City of Alexandria, Virginia

MEMORANDUM

SUBJECT: 3RD CONCEPT REVIEW OF 802-808 NORTH WASHINGTON STREET
(TOWNE MOTEL)
BAR CASE # 2015-0154

OVERALL SITE
PLAN

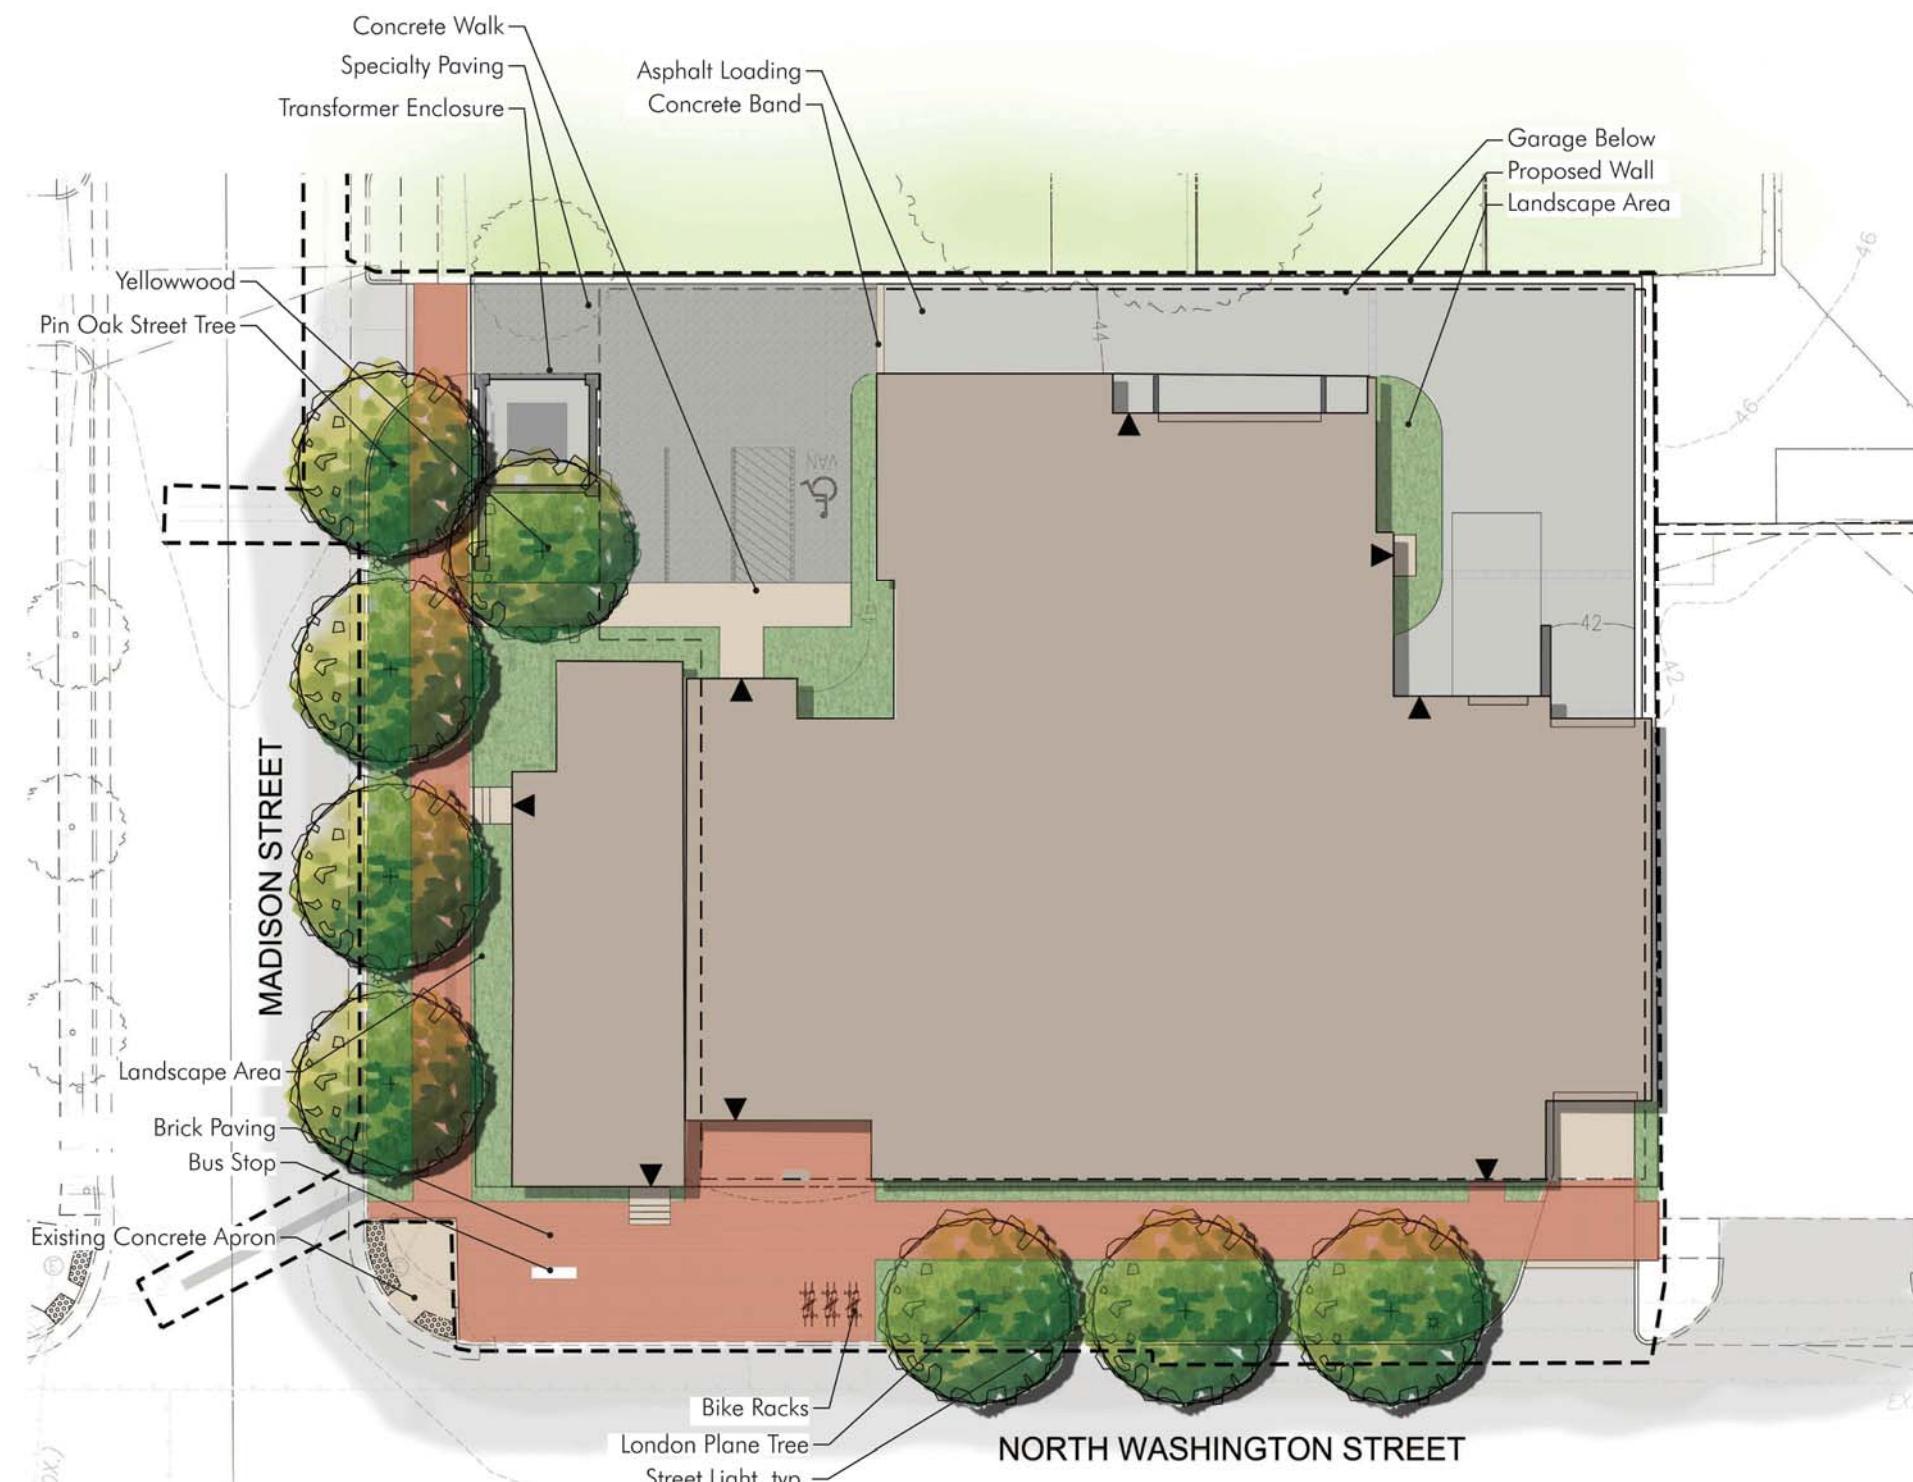
C-1 Per the Zoning Tabulation table on Sheet No. A1, the gross floor area is 58,844 sq. ft. and the net floor area is 49,370 sq. ft., the applicant must show proposed areas excluded from the floor area calculations.

C-5 Show the location and size of all proposed exterior mechanical, HVAC equipment, and screening at ground level and/or on rooftop.

C-6 Show the location and size of all dumpsters and enclosures at ground level.

Response: Still Required

Response: Acknowledged

Response: Still Required; Dumpsters must be shown

A2.2b

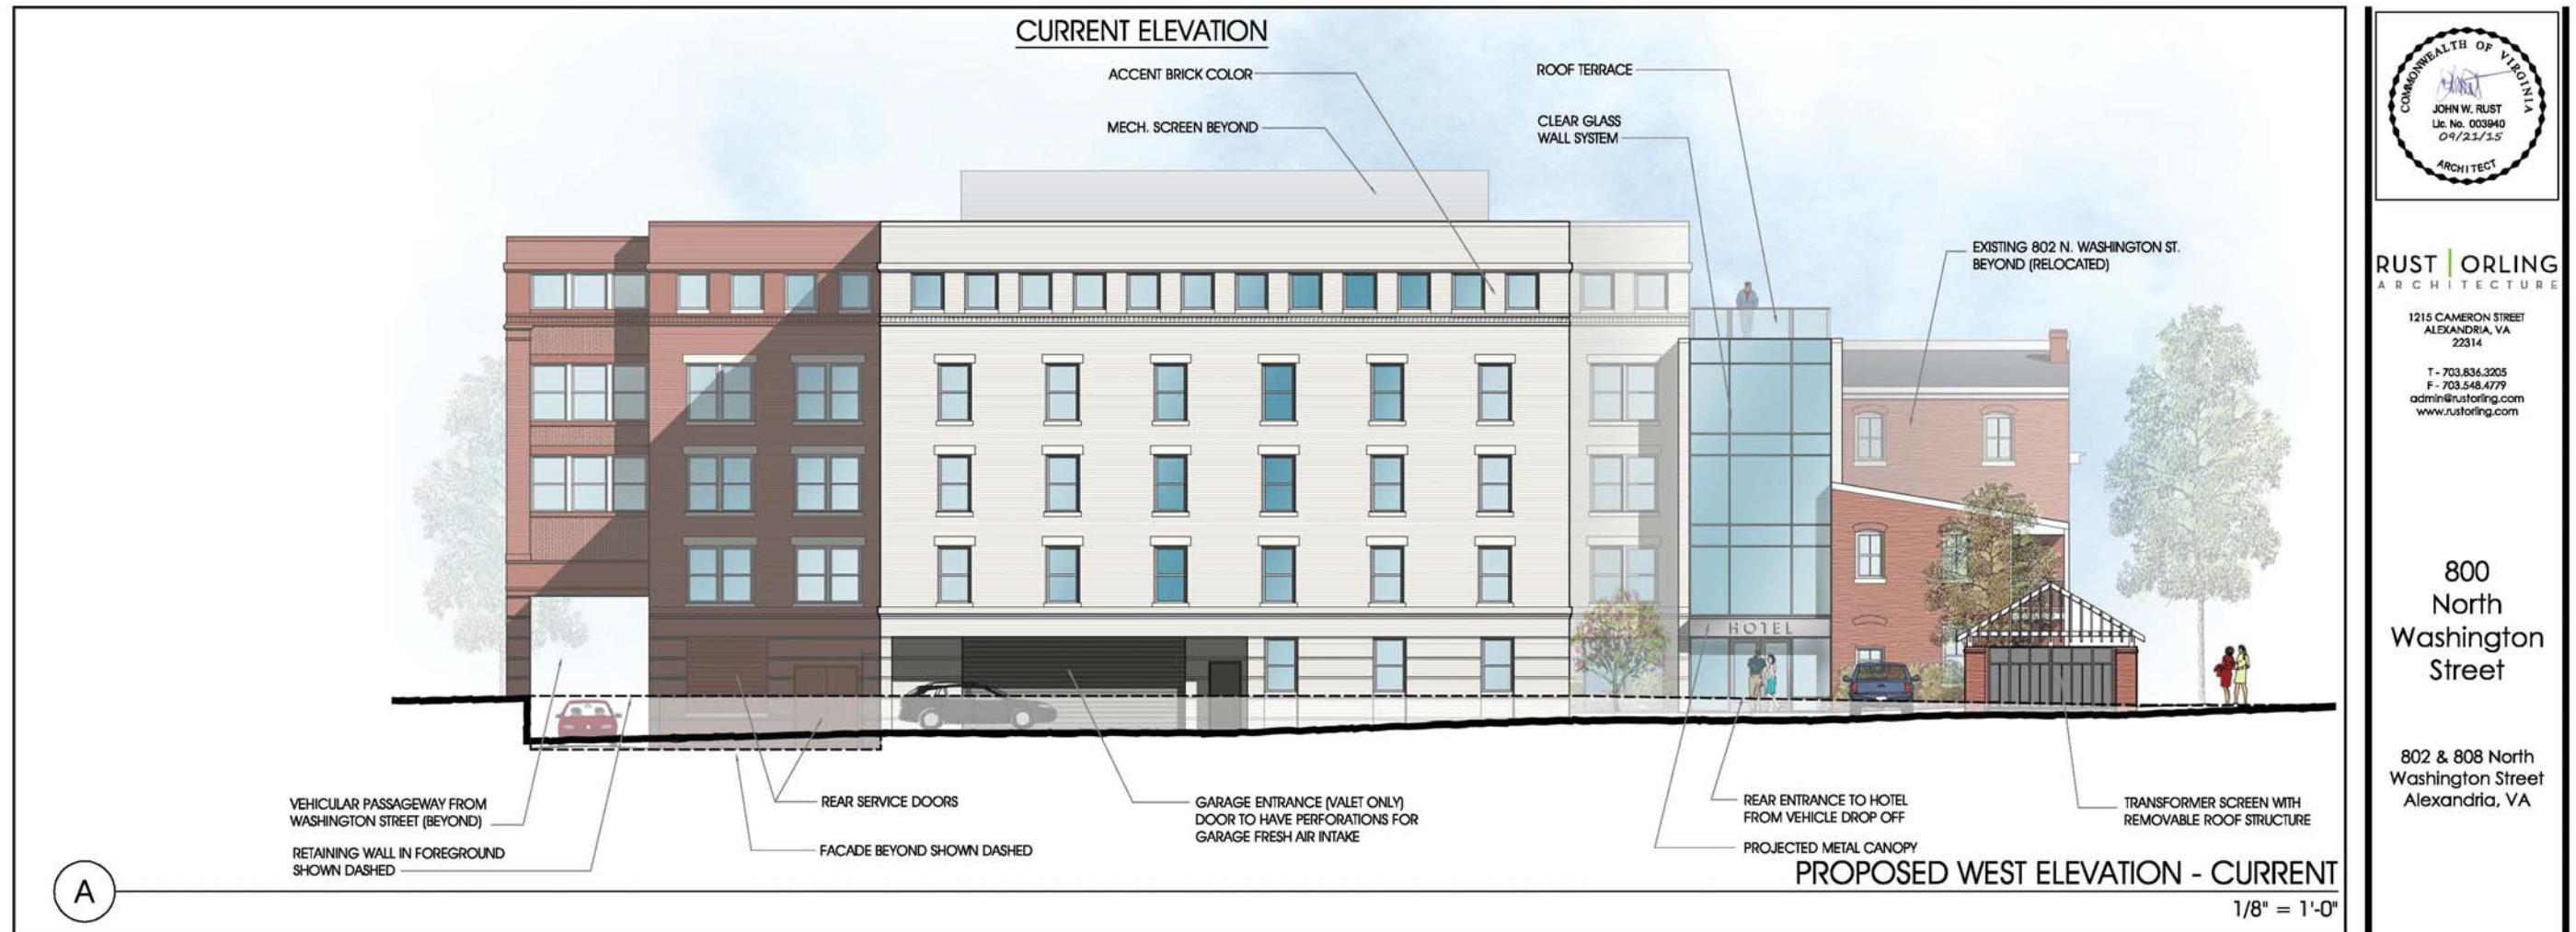
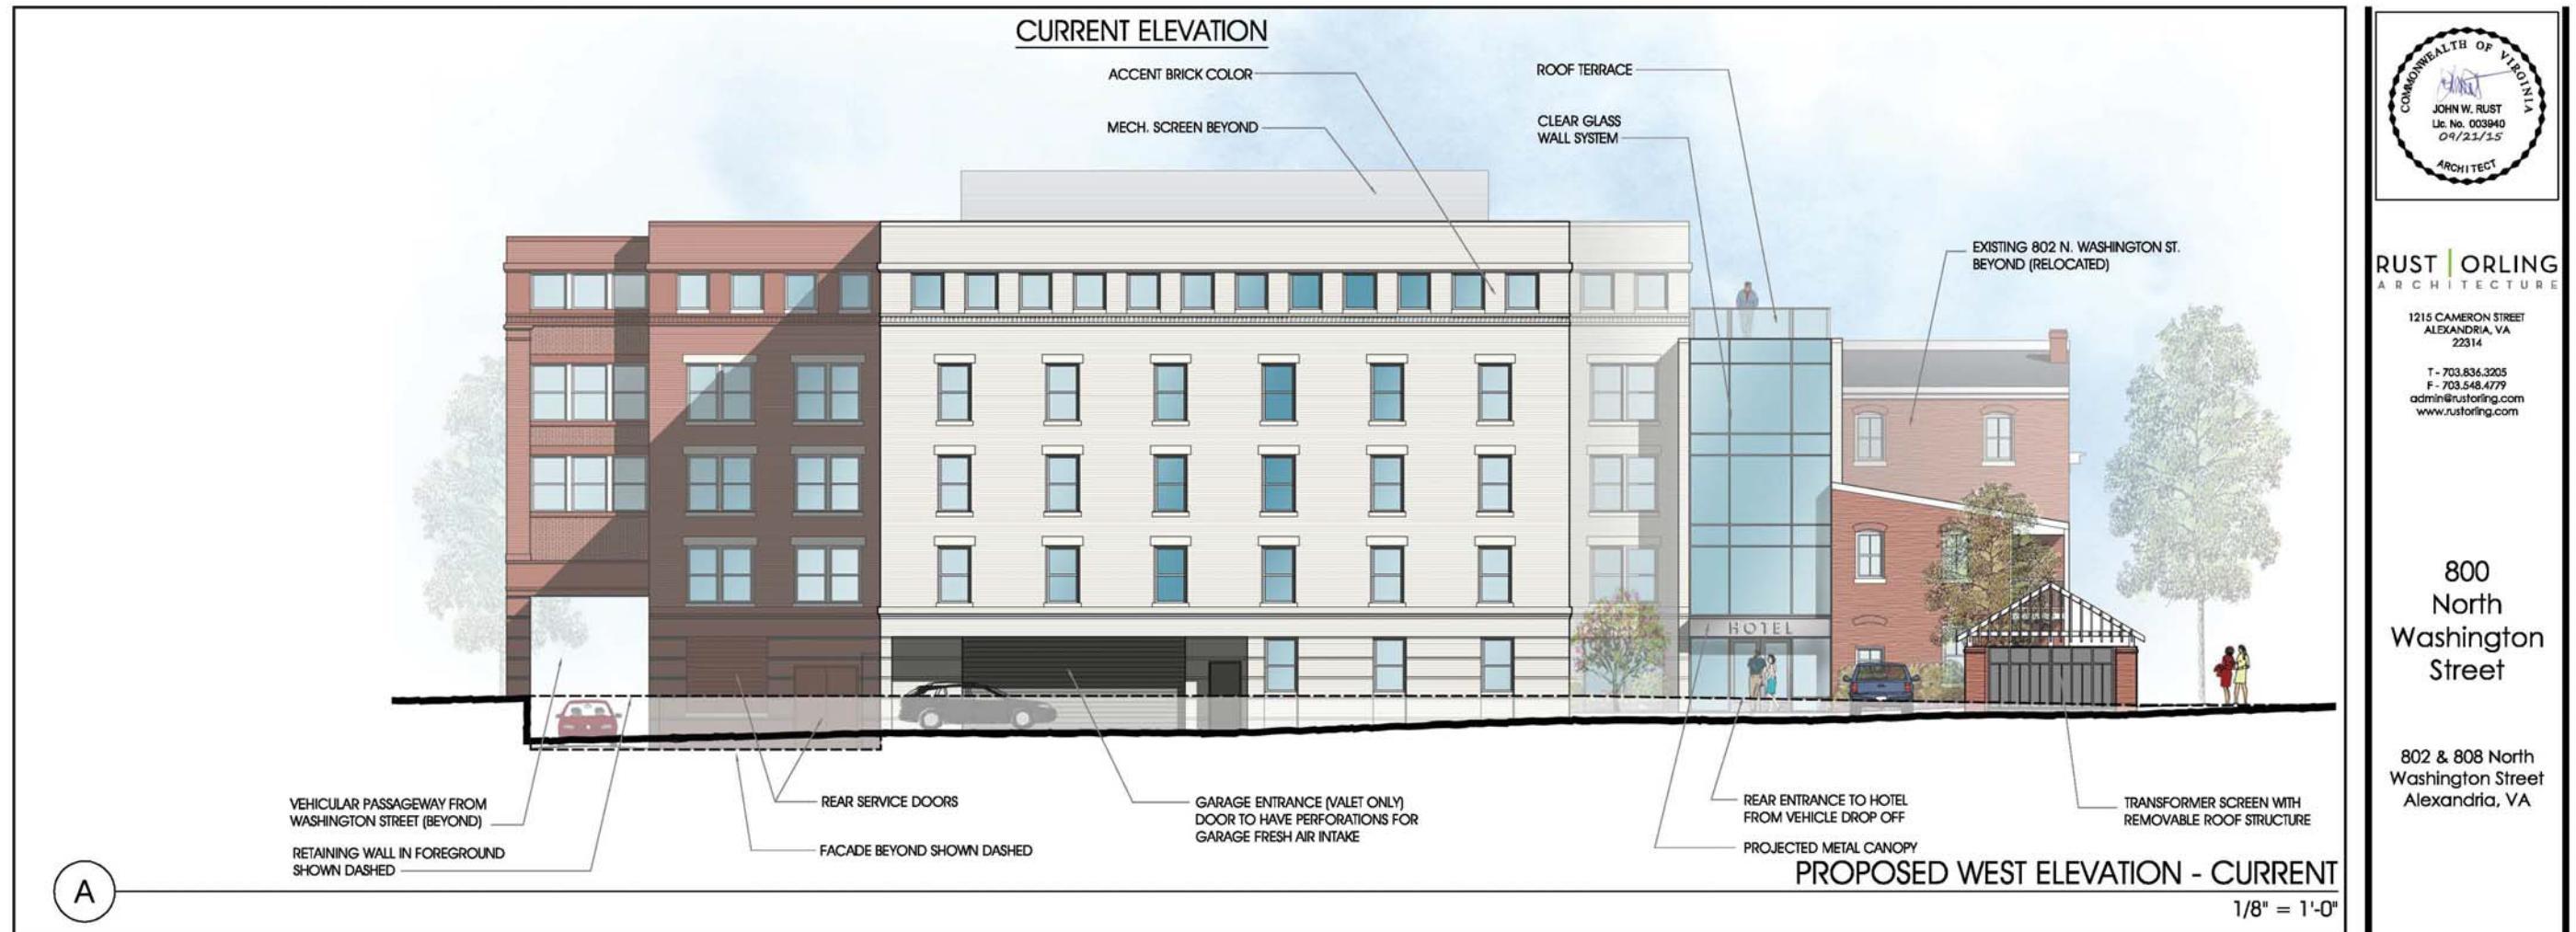
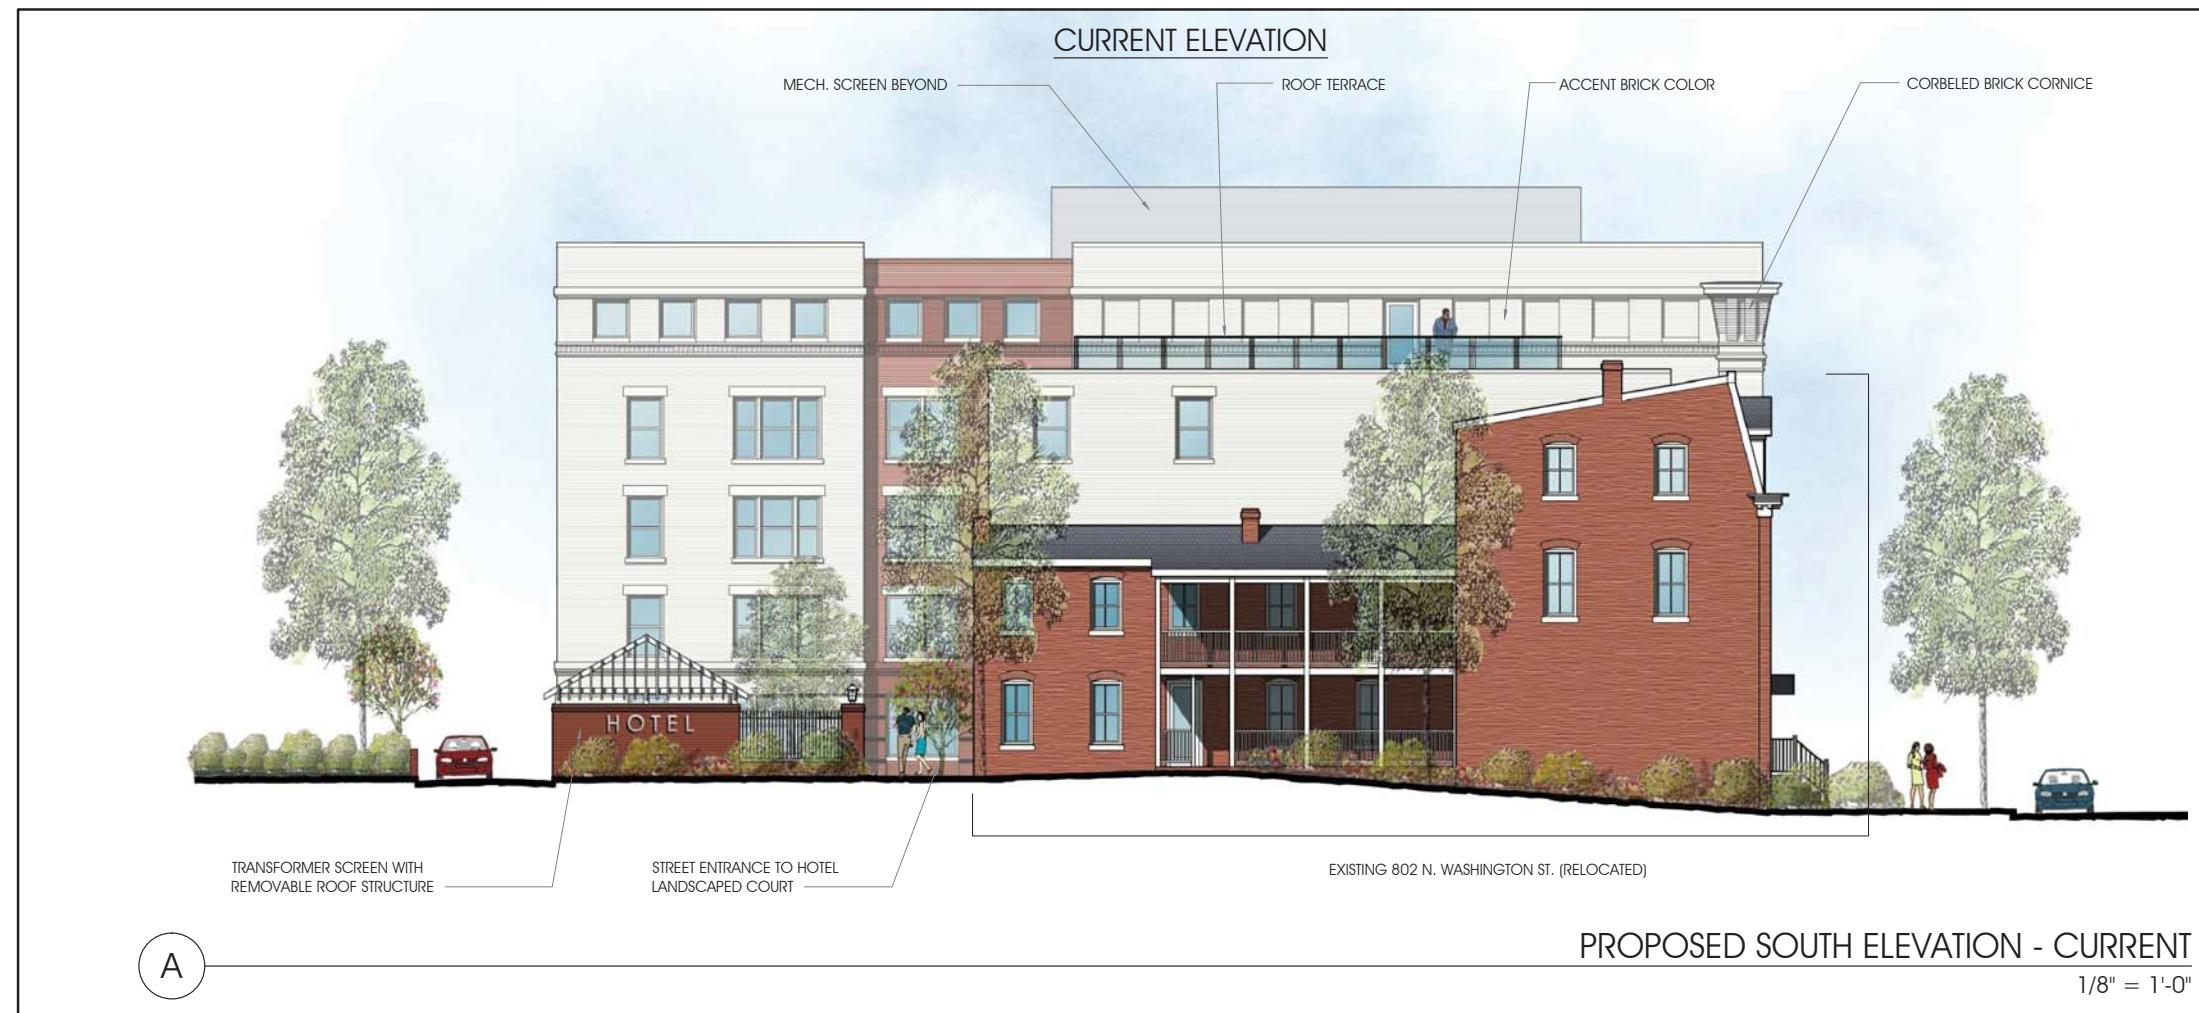
The, side (north and south) and rear (west) elevations are now coordinated, fittingly detailed and contribute to the overall appropriateness of the design.

Ms. Roberts liked the revisions to the north wall, especially the brickwork. She asked whether the hyphen connecting to the historic house, would be white brick. The applicant said that the rendering was white so that the building forms could be viewed with the distraction of color and that they will return with colors proposed for approval during the Certificate of Appropriateness application. Ms. Roberts preferred the less busy hyphen and the reduction in its scale, especially next to the historic building. However, she thought the glass hyphen worked better than the revised brick version, and that perhaps it could be one story lower. Regarding the north entrance, she observed that while it is set back eight feet, it is also taller than the previous version, but she supports the way it is. She did not care for glass mansard roof and cited the Time Life Building as an example of a mansard that overwhelms the building. She suggested a flat roof here, with a lower roofline. Lastly she confirmed that there would be differentiation in the brick colors between the two primary building masses.

in other parts of town. He suggested recessing the top level and reducing the massing. He found the north side much improved and liked the projecting pilasters. The revised west side is much more coherent.
